TECHNICAL BULLETIN

NO. 214-78-18

SUBJECT: REINFORCEMENT/REPAIR OF TAIL BOOM
P/N 214-030-003-7

HELICOPTERS AFFECTED: All Model 214B/R1 helicopters

FIGURE 1

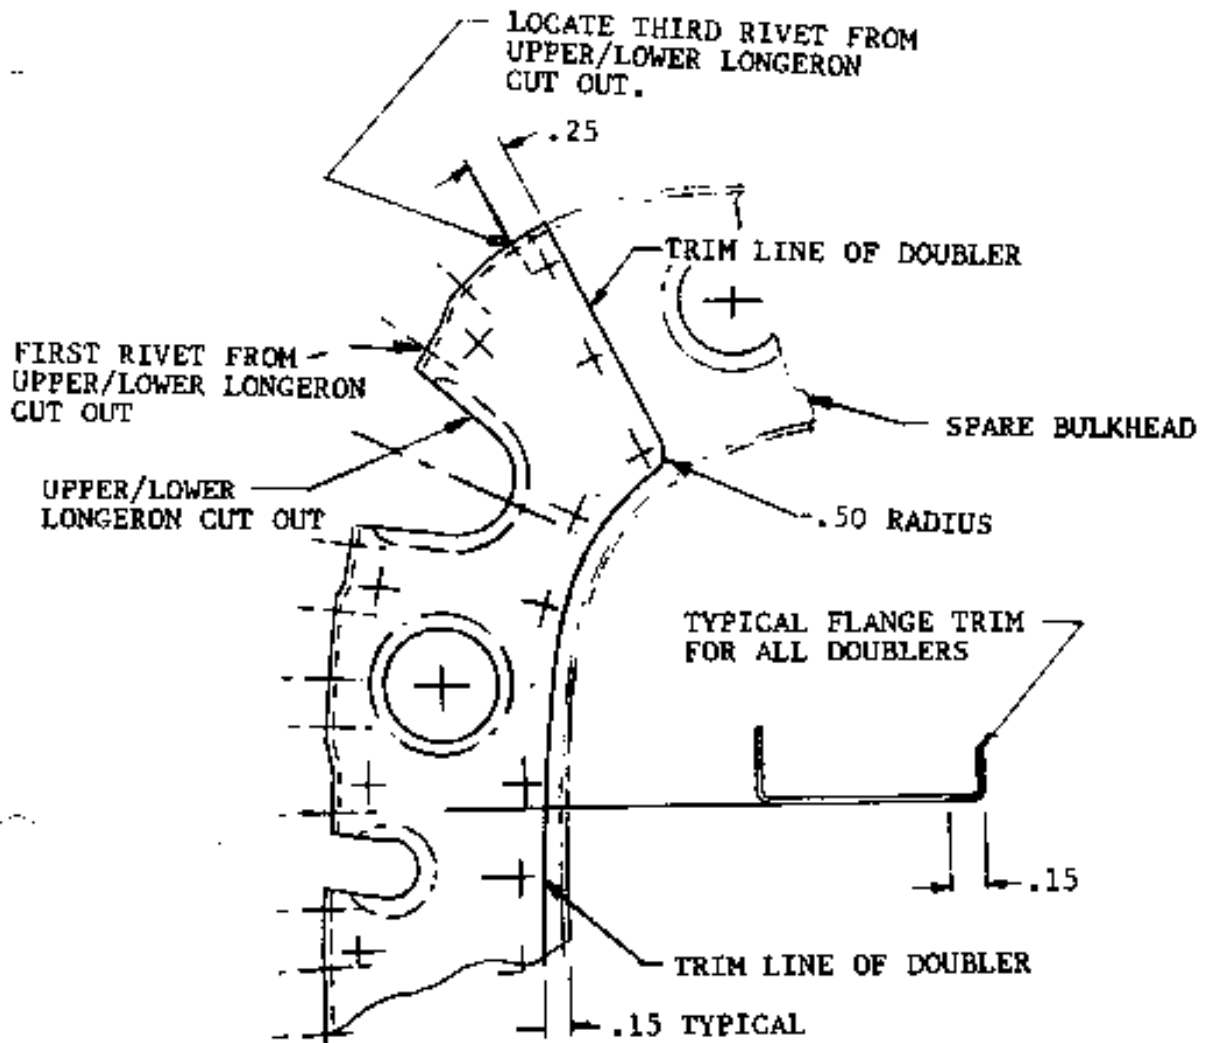
1. Refer to figure 1. Gain access to the interior of the tail boom by removing all the lower access panels.
2. Inspect each bulkhead in the area of the longerons and "J" stringer for cracks. If crack or cracks are found stop drill with a No. 40 drill.

FIGURE 2

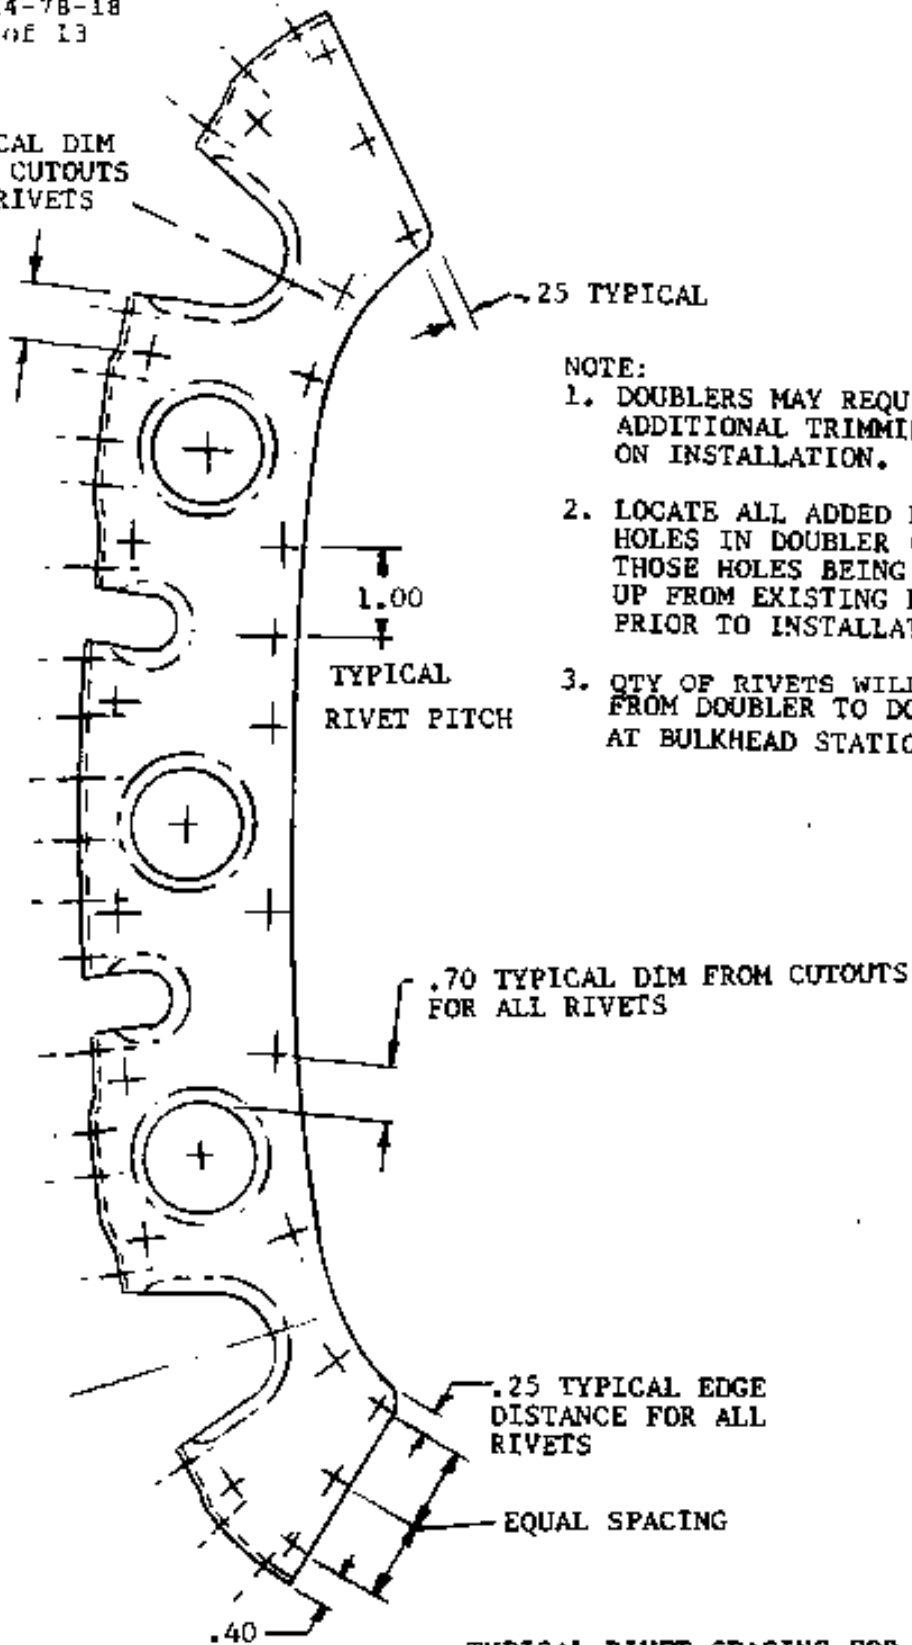
3. Refer to figure 2 and 3. Cut doublers from each spar bulkhead. Locate and drill No. 40 pilot holes, all added holes. Mark each doubler set with bulkhead part number.

FIGURE 4

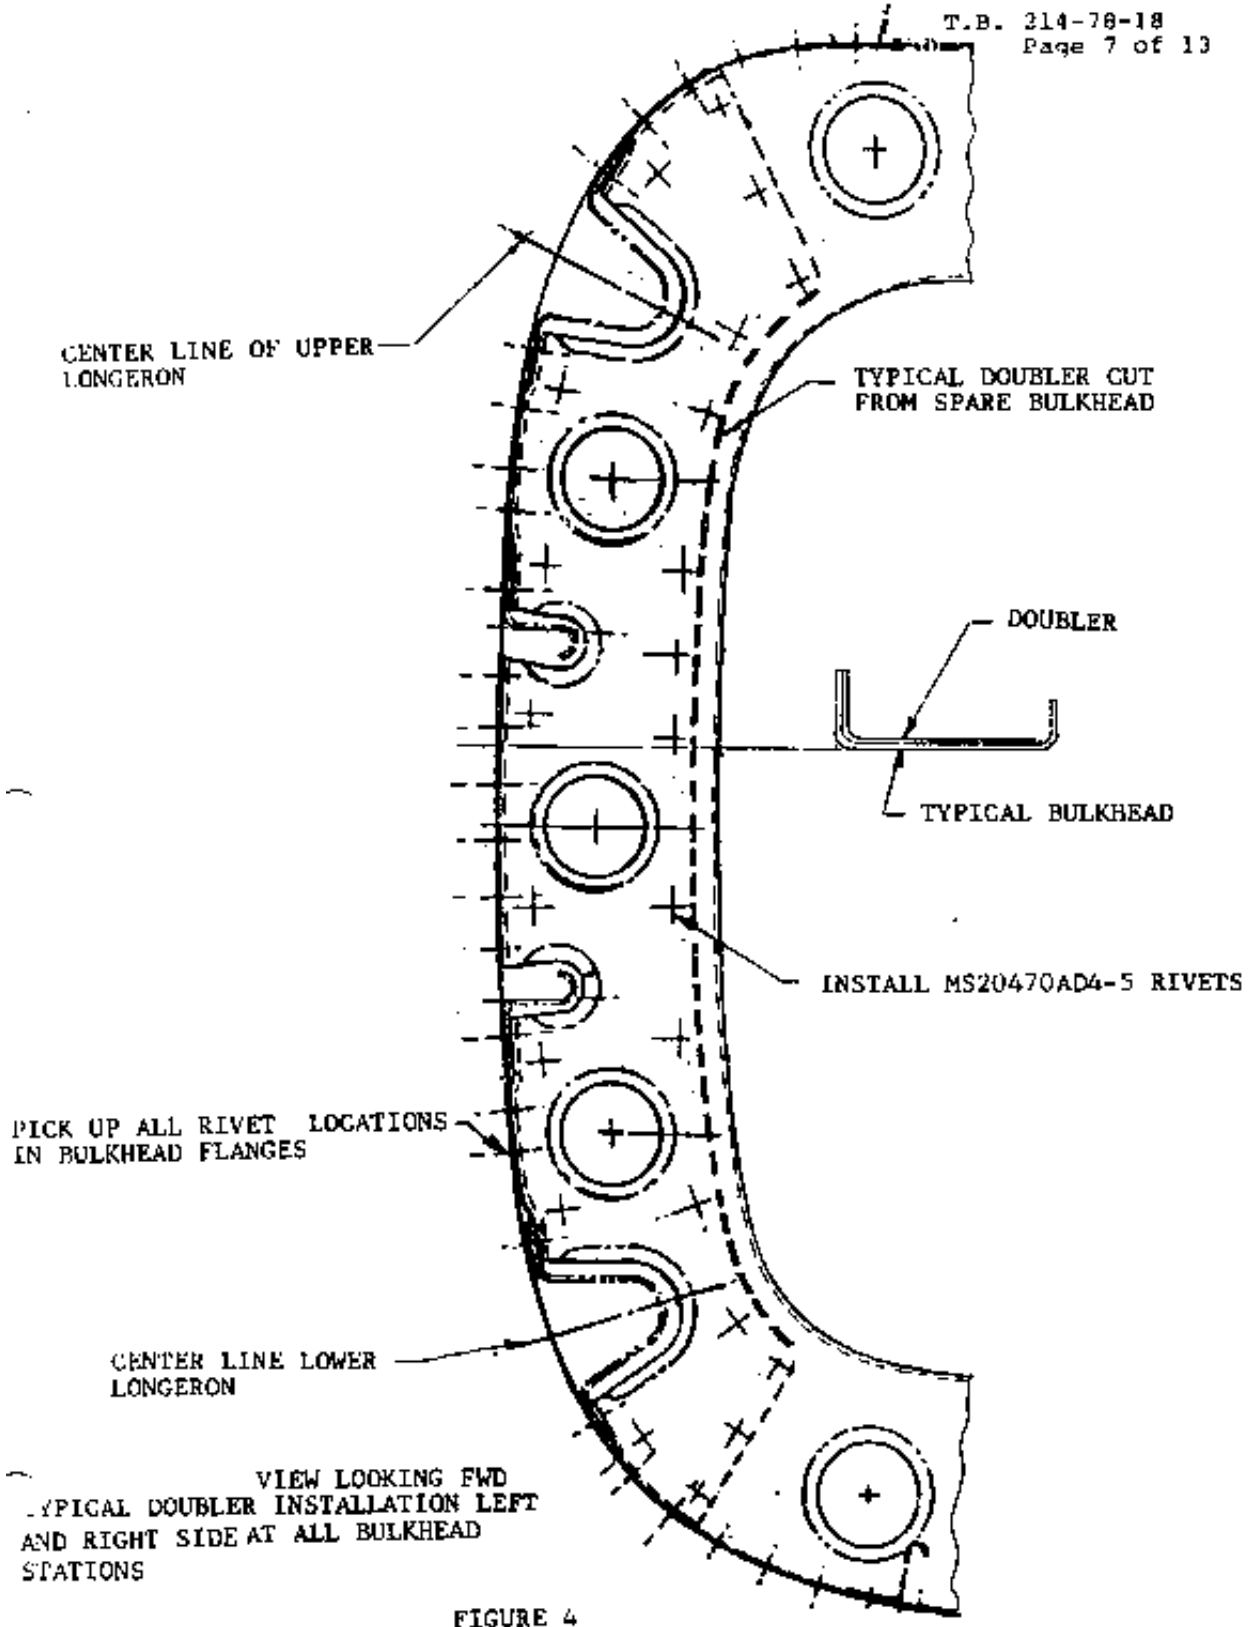
6. Refer to figure 4. The following instructions are typical for all bulkhead to be repaired. Remove all rivets that fall in the area to be covered by the doubler. Fit the doubler to nest into the bulkhead flange (doublers may require additional trimming to suit each condition). Pick up all holes in the doublers from the bulkheads and all holes in the bulkhead from the doublers. De-burr all holes.

FIGURE 5

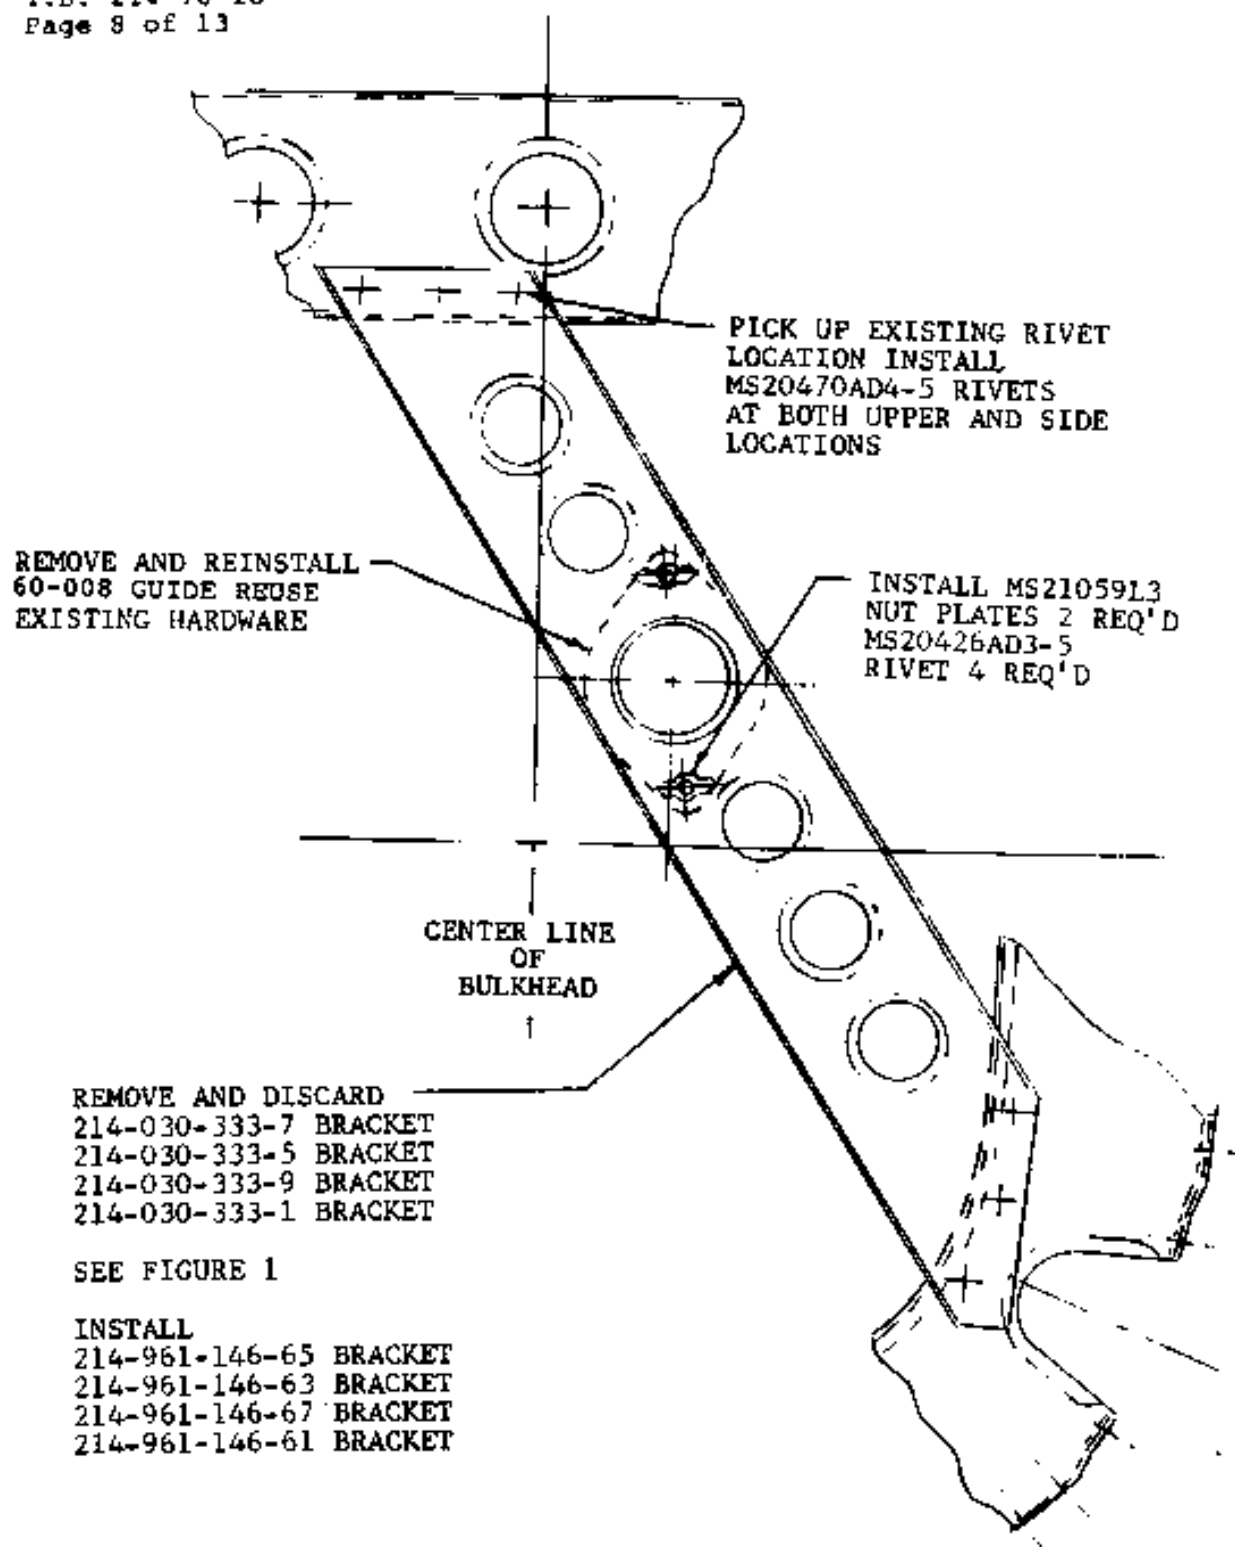
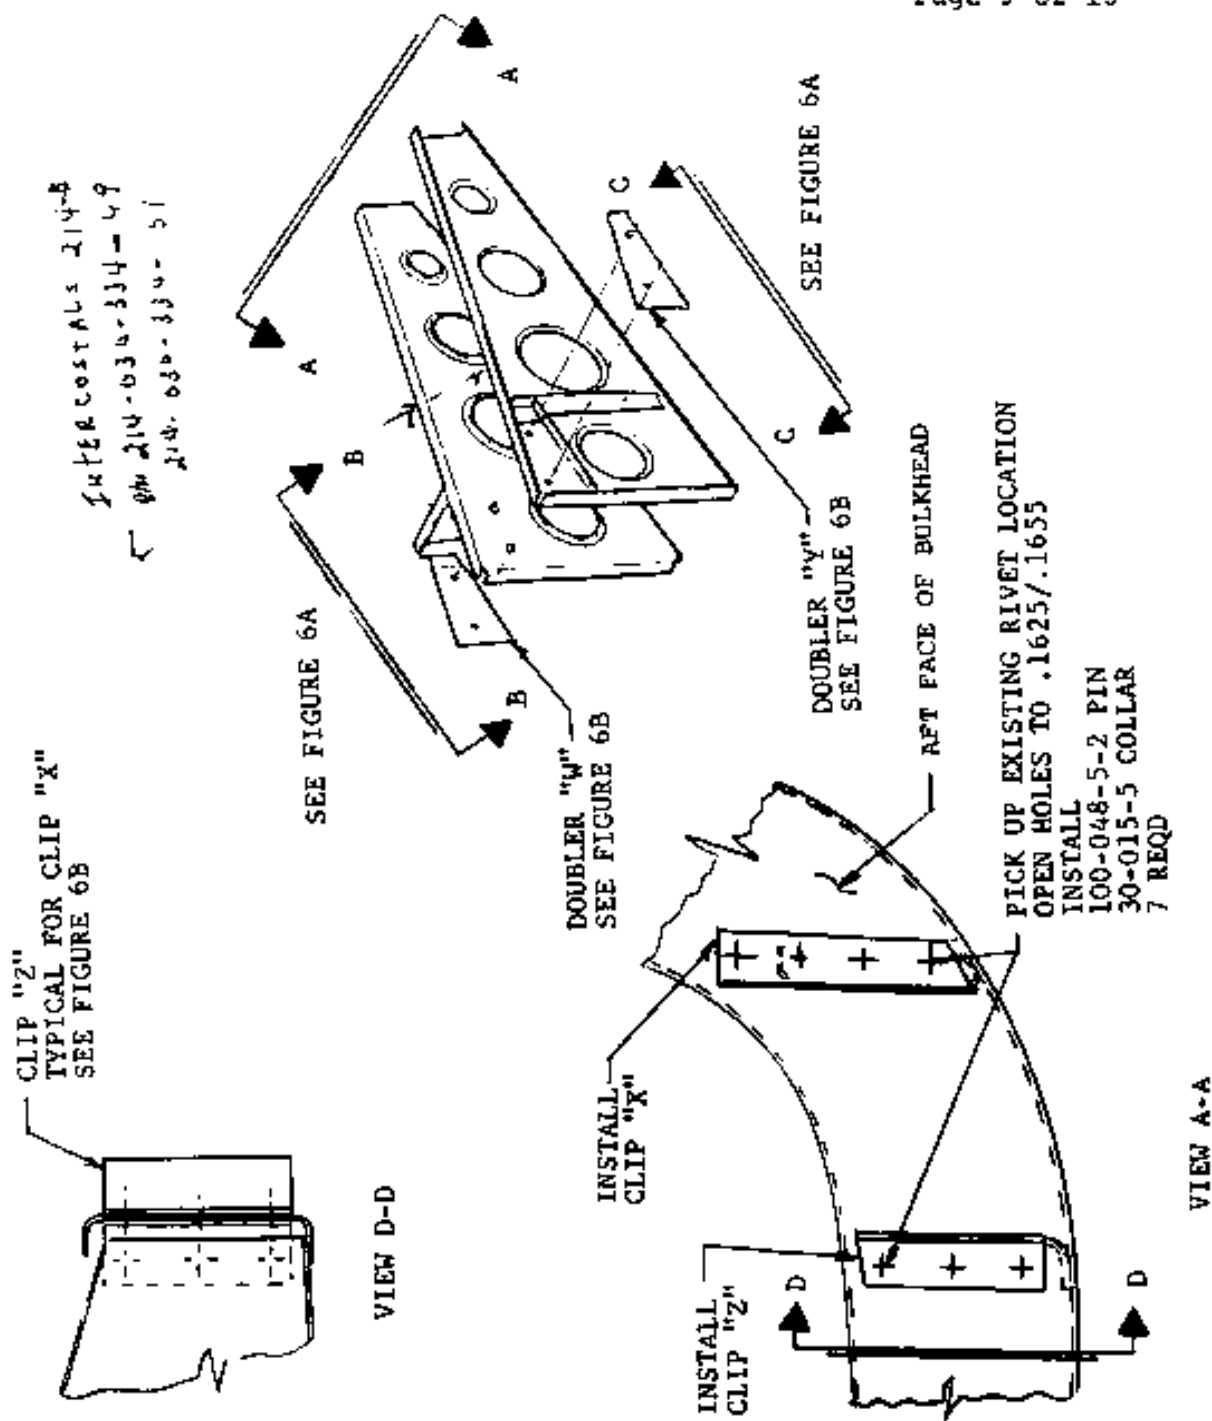
4. Disconnect and remove from the guide brackets all control tubes that will interfere with the installation of doublers and new guide brackets.
5. Refer to figure 5. Remove guide brackets from bulkheads. Remove the guides and retain the hardware. Install the nutplates to the new brackets, reinstall the guides with retained hardware.

7. Refer to figure 5. Install new guide brackets.
8. Refer to figure 6B. Fabricate doublers "W" and "Y" and clips "X" and "Z". Alodine and prime with epoxy primer.

FIGURE 6

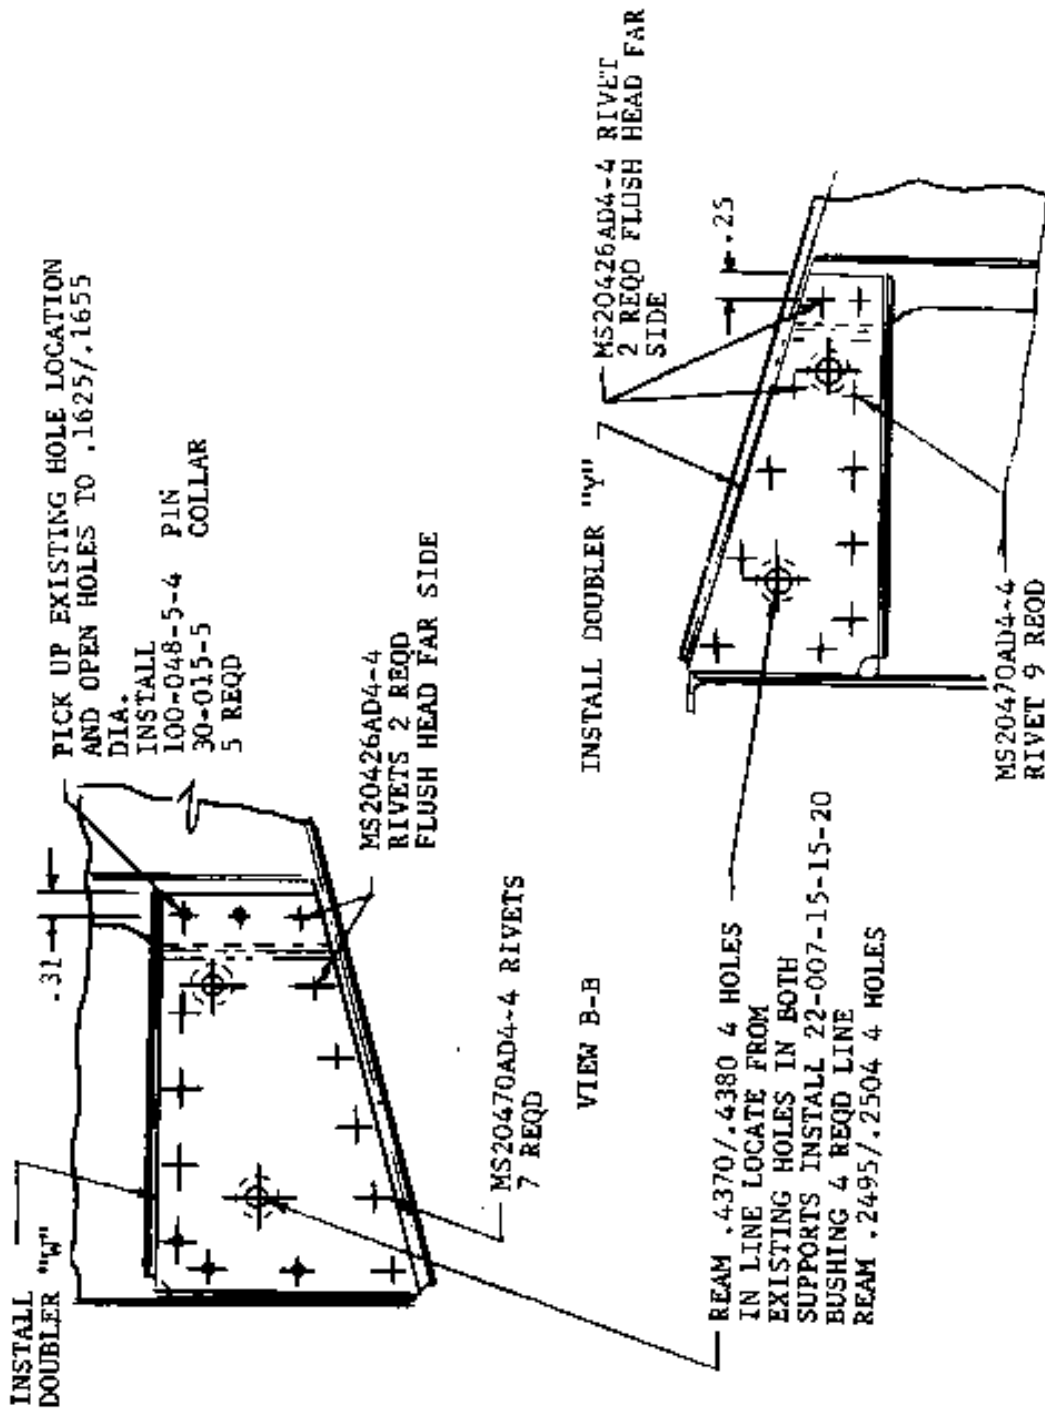
9. Refer to figures 6 and 6A. Remove the elevator and anti-torque, control bellcranks from support assembly. Remove rivets that fall in the area to receive the doublers. Remove (4) bushings two each side. Temporarily attach doublers and pick up existing holes, de-burr all holes. Locate and install doublers, ream hole and press the bushing in.

10. Refer to figure 6. Remove the rivets attaching the aft clip to the bulkhead. Temporarily attach the clips, pick up existing holes, de-burr all holes. Install clip with Hi-Lok pins and collars.
